Downscaling Proposal

India Short validation results
India Proposal

India Presentation
5th June, 18th DHC Meeting,
Geneva.

Downscaling – Class I

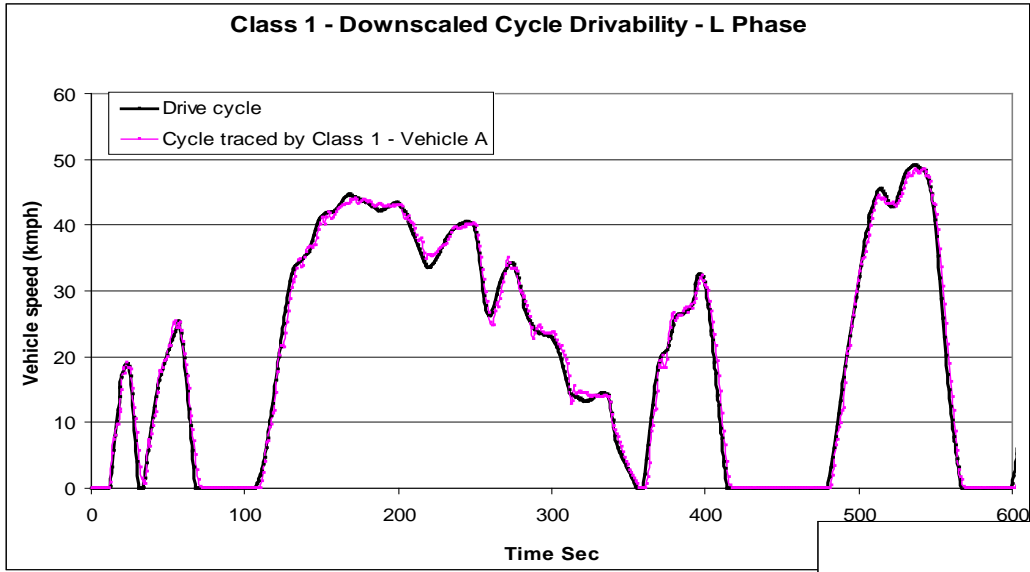
Downscaling leads to truncation of cycle similar to Capping. This needs correction similar to Class III Vehicle downscaling concept

Vehicle E: Gasoline Class II – EXH Phase

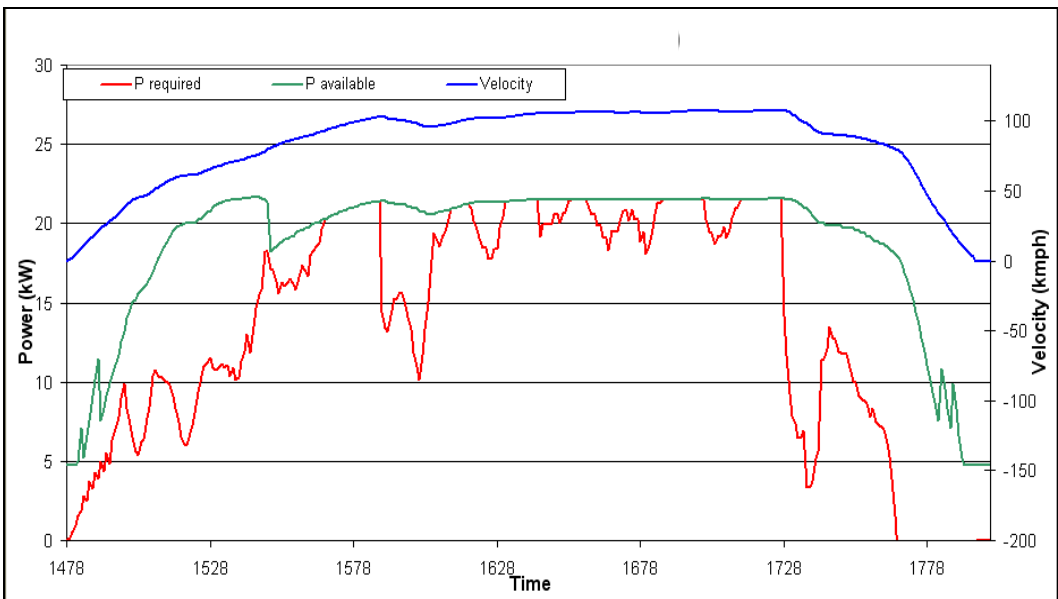
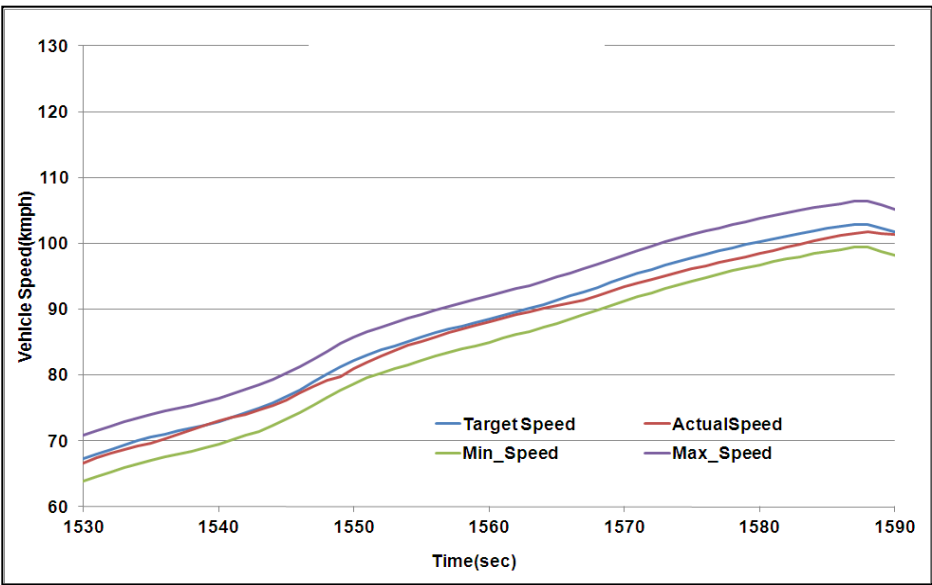
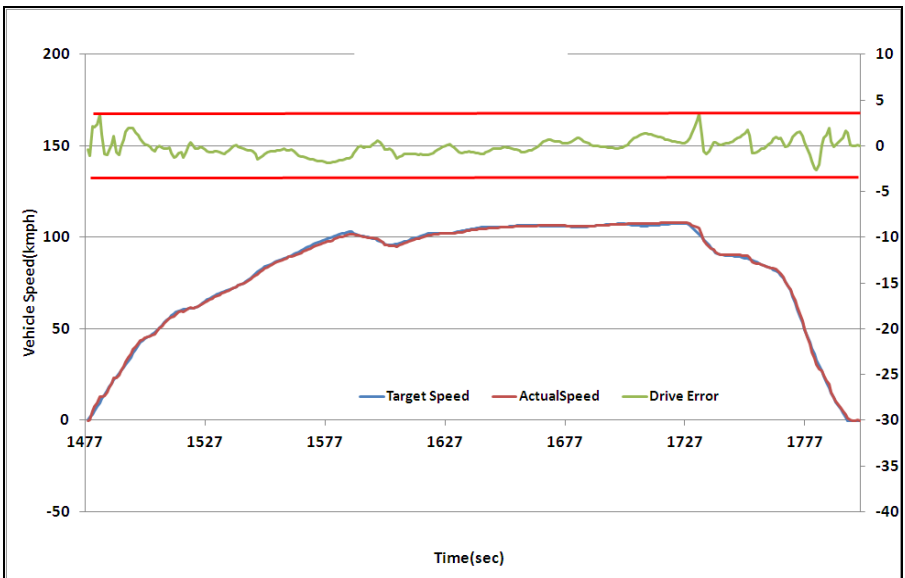
- 1. Cycle Traceability :
 - a. Steven Downscaling factor = 23 %
 - b. Vehicle able to follow the targeted trace
 - c. **40% of operation is in near WOT area** in EXH phase. Component protection area operation is very high

Vehicle F Gasoline Class III – EXH Phase

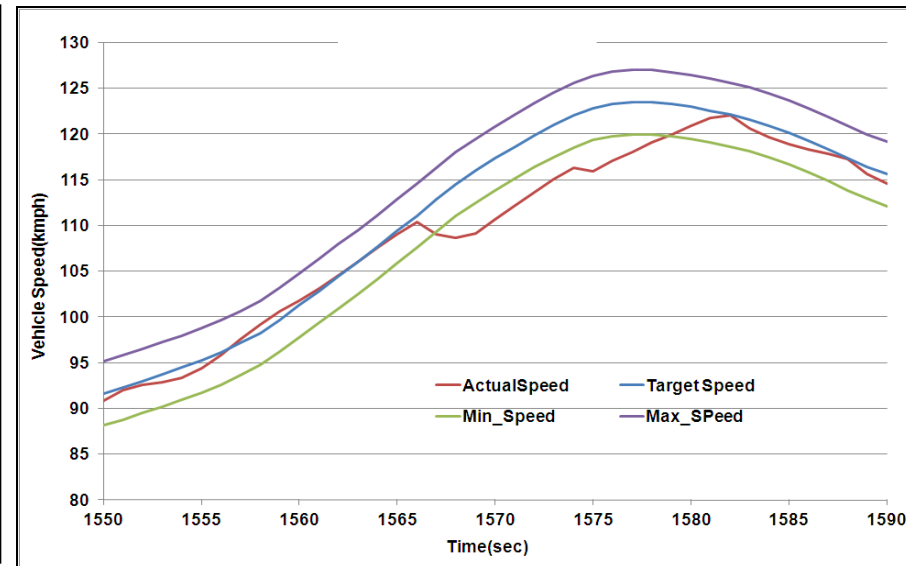
- A) N norm max: Set Value 120% in new tool, which leads to very high Engine RPM's, Engine hitting the rev limiter, resulting in errors

- This is not a natural driving behavior!
- This Results in driving error from target
- Creates artificial downscaling requirements

Proposal: N-Norm max set value of 90% as in previous tool should be used

Comparison of N_norm_max =120% and 90% - Vehicle F Class III

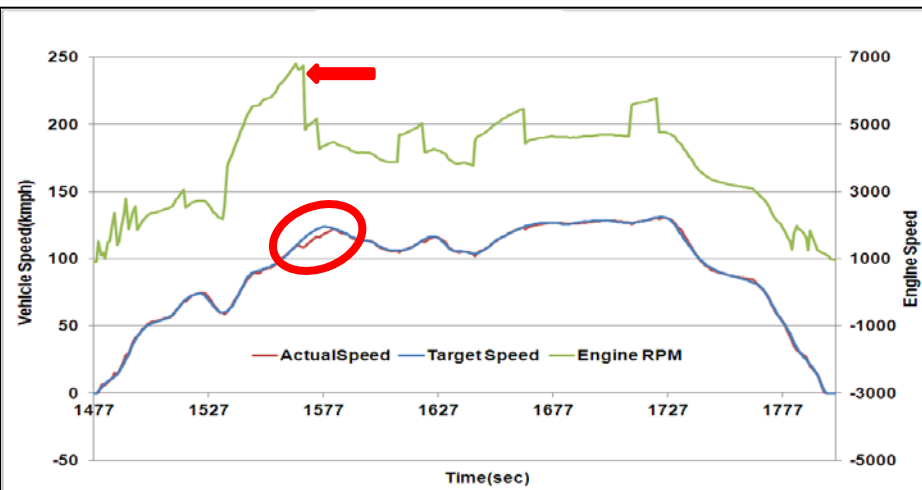
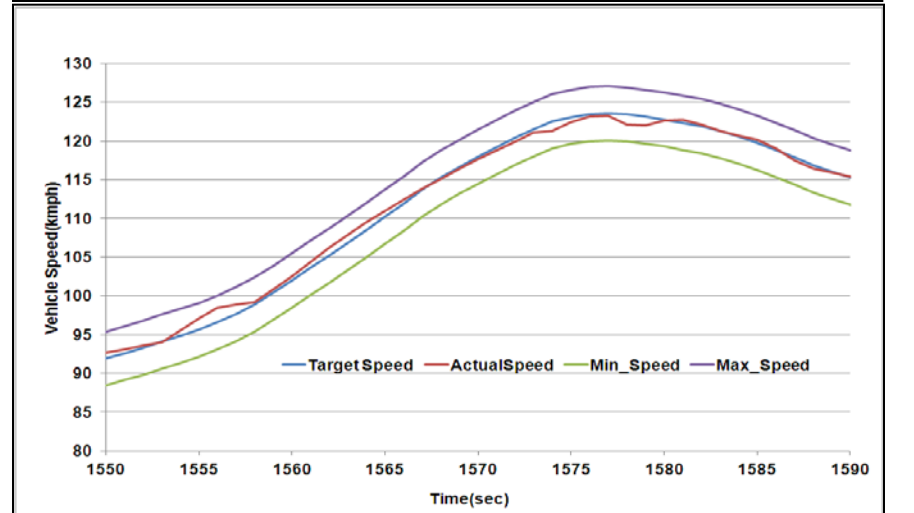
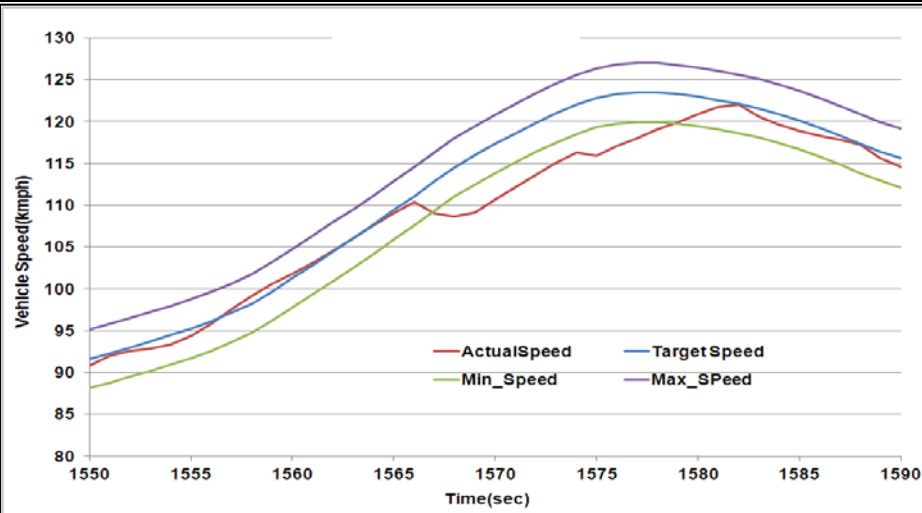
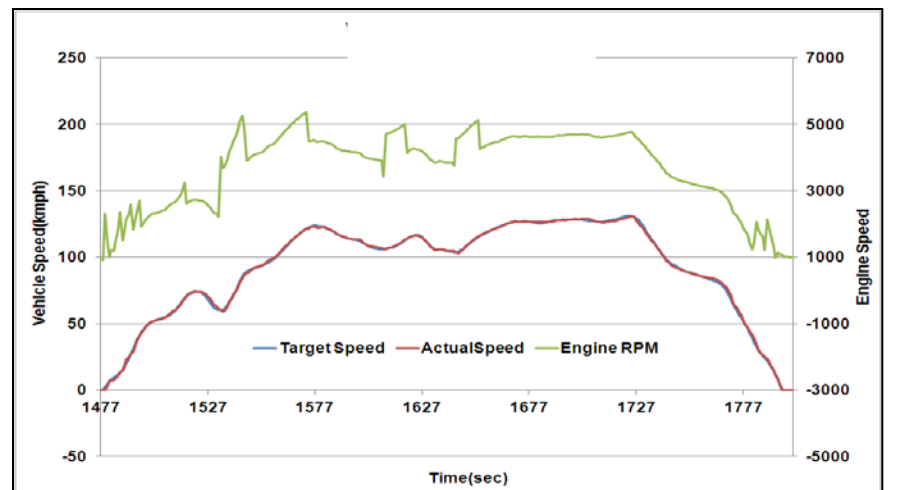
1. With N_norm_max=120% Engine RPM in cycle reaches maximum permissible limit.
2. Fuel Cut results in sudden power loss and deviation from targeted trace, whereas with 90 % n_norm_max vehicle follows the trace . With 120%, artificial downscaling requirements get created

Comparison of N_norm_max =120% and 90% - Vehicle G Class III

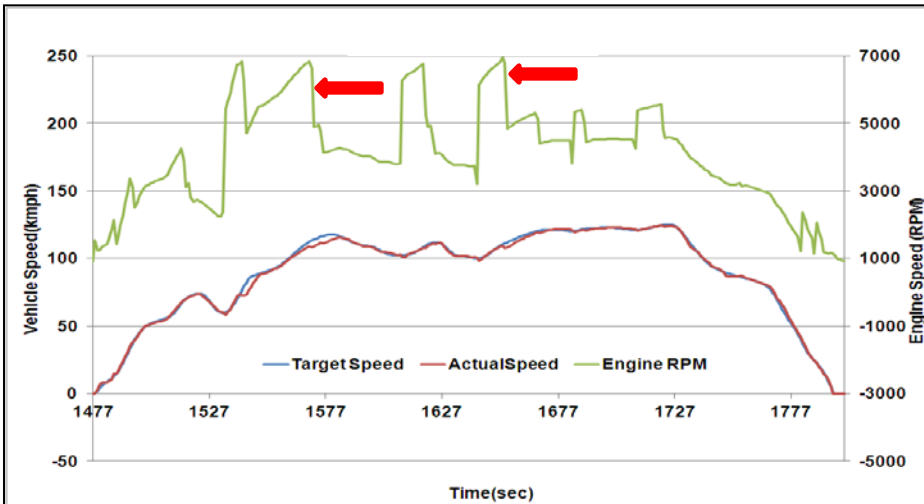
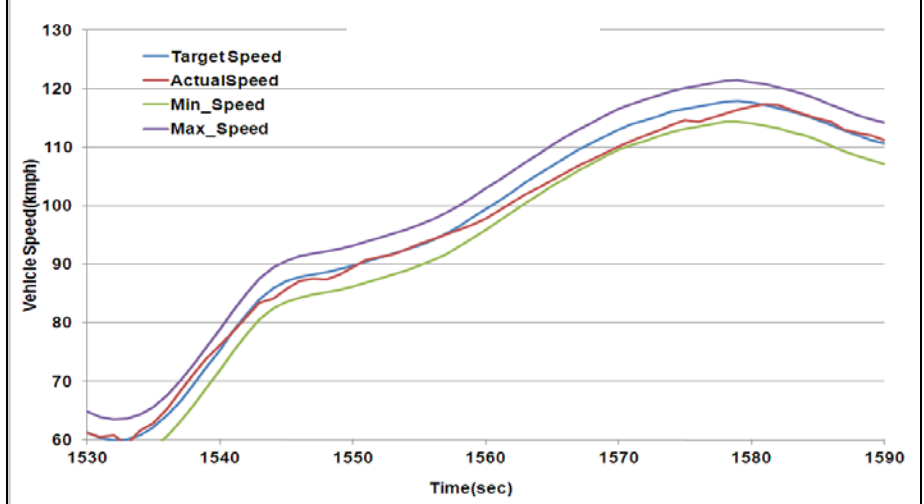
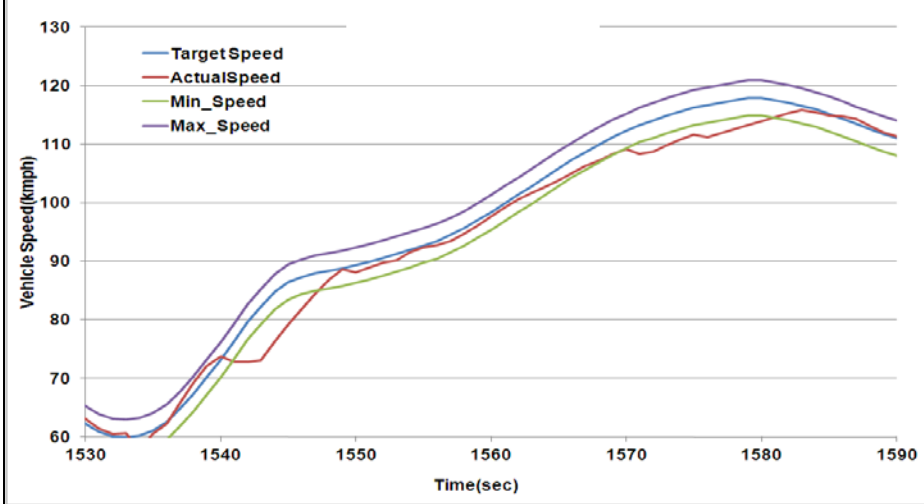
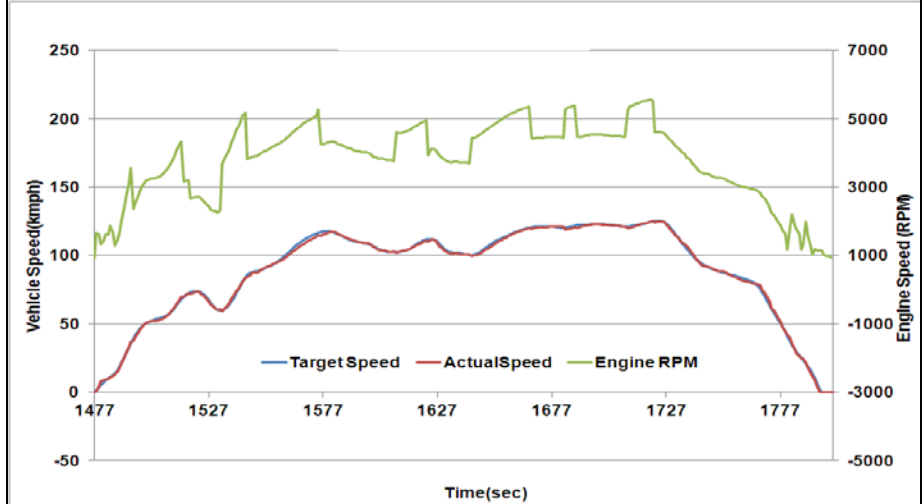
1. With N_norm_max=120% Engine RPM in cycle reaches maximum permissible limit
2. Fuel Cut results in sudden power loss and deviation from targeted trace, whereas with 90 % n_norm_max vehicle follows the trace.

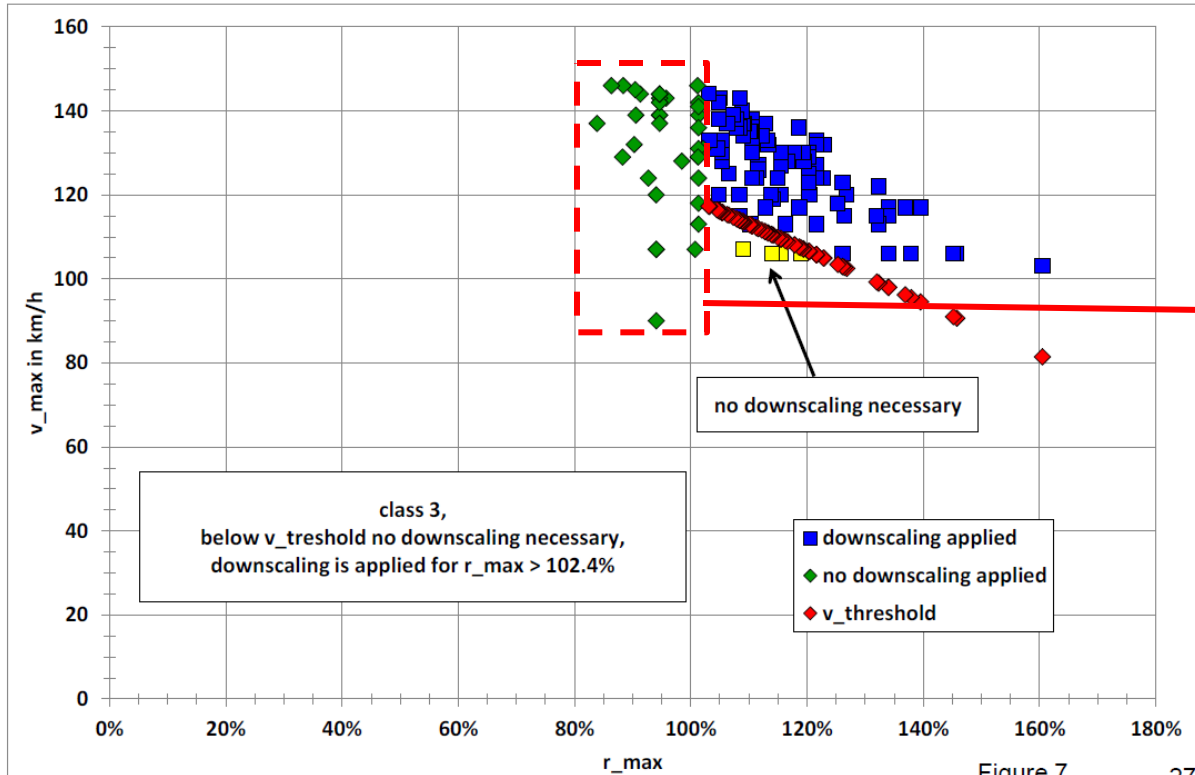
B. R max : $r_{0_} > 1$ for downscaling applicability.

This means that demand power should be higher than engine rated power

Downscaling will be required if $P_{req, max, i}$ is higher than P_{rated} , with a margin

f_dsc versus r_max, class 3

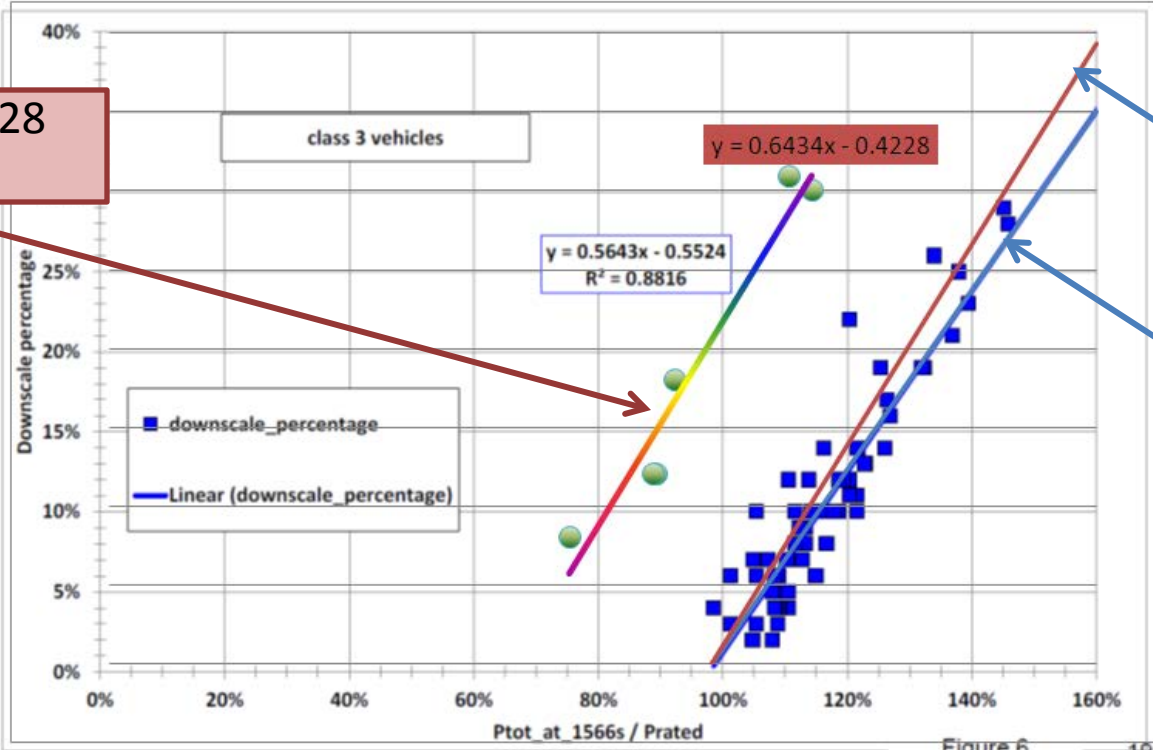
Vehicles may be able to trace the cycle but will have high P_{WOT} rates

Example: Vehicle with $P_{req,max,i} / P_{rated} = 89\%$.
Vehicle available power = 90%.
Difference is only 1% which will result in high P_{WOT} .

Downscaling will be required if $P_{req,max,i}$ is higher than P_{rated} , with a margin

Proposal 1– Considering operation times > 90% of available Power

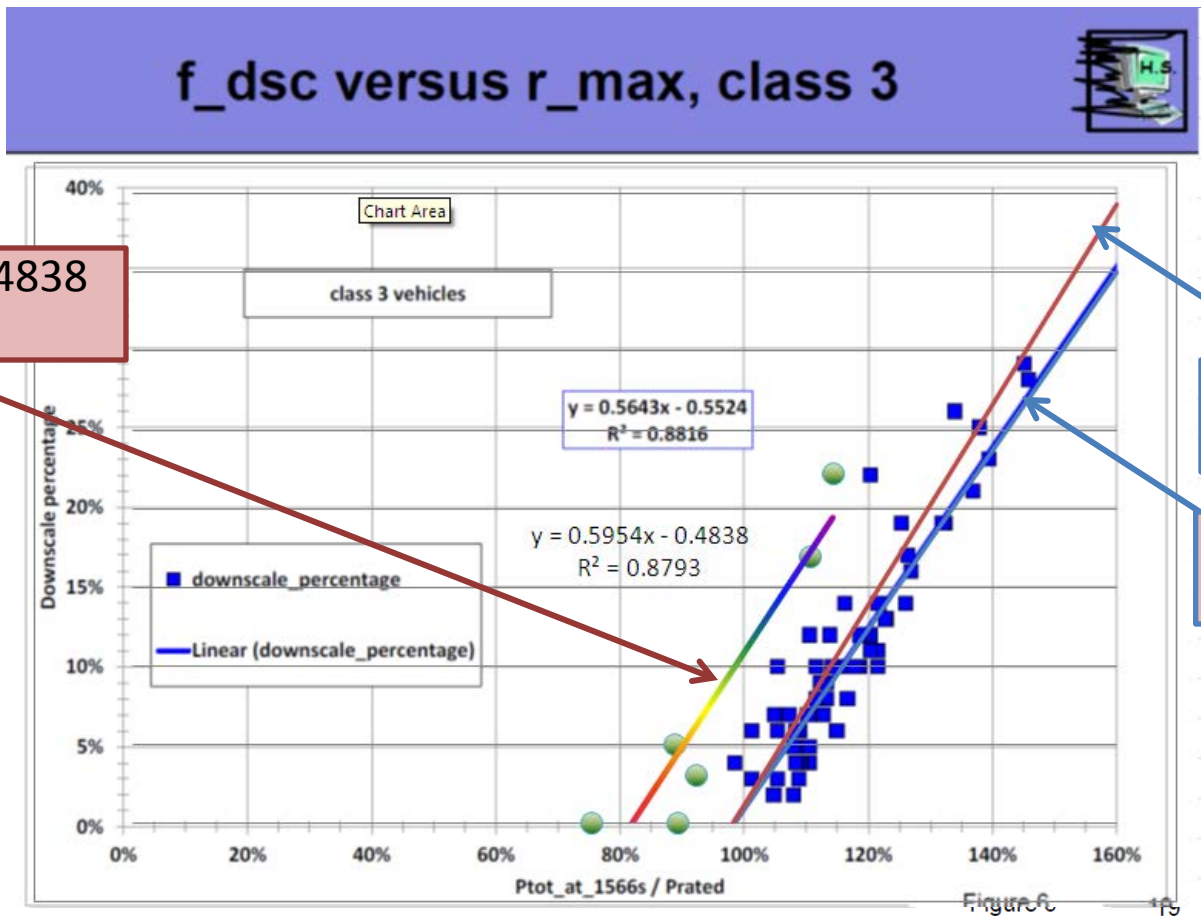
Normal running of vehicles as per road data collected shows near WOT operation < 2%

Considering vehicle running above 90% of available power for ~5% time in EXH phase

Proposal: May give some undue advantage to some vehicles (dropped). EXH operations with required power >90% of available power for 5% of times is equivalent to around 3~4% on overall cycle

Proposal 2– Considering operation times > 95% of available Power

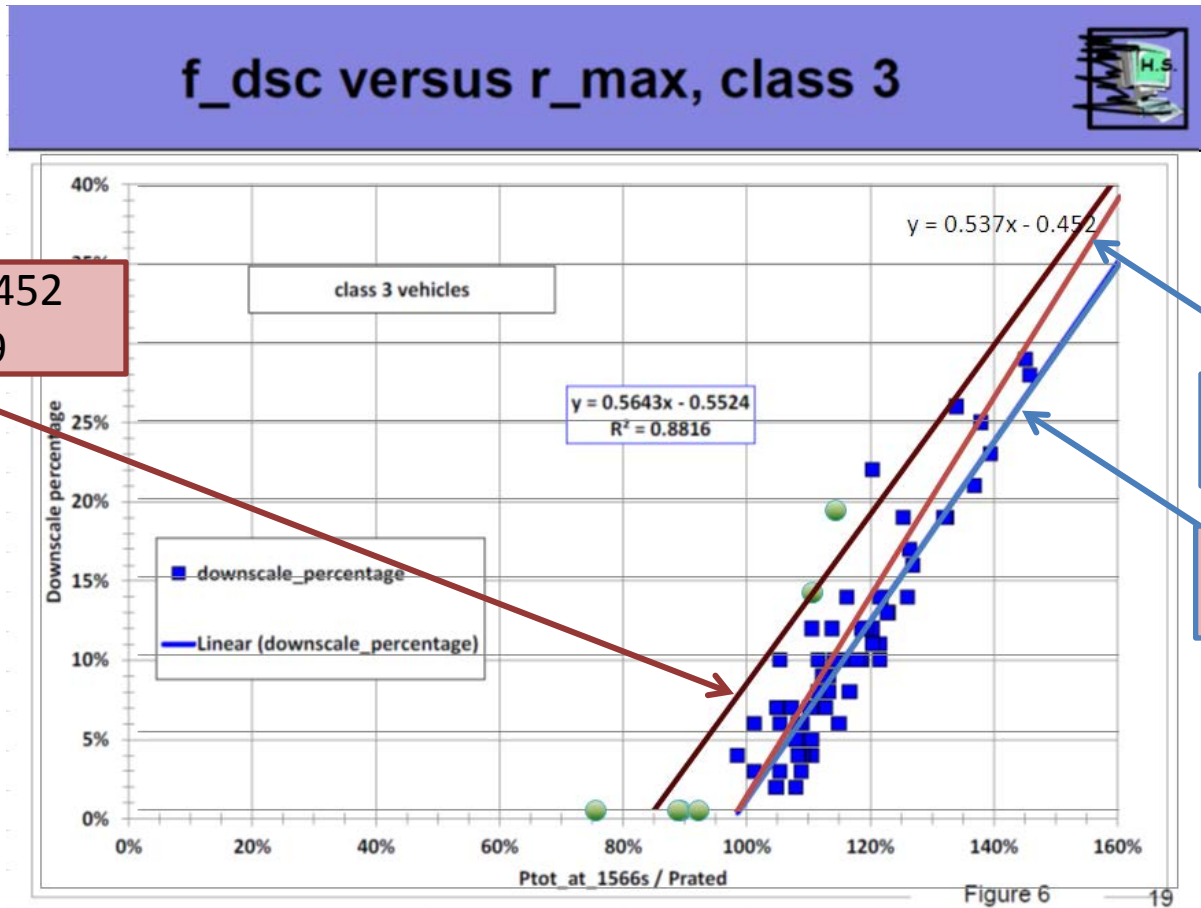
In order to rationalize further, operation times only above 95% of available power were considered. Criteria was to limit these conditions to 5% of operation times in EXH phase

Proposal: Looks reasonable. EXH operations with required power >95% of available power for 5% of times is equivalent to around 2% on overall cycle.
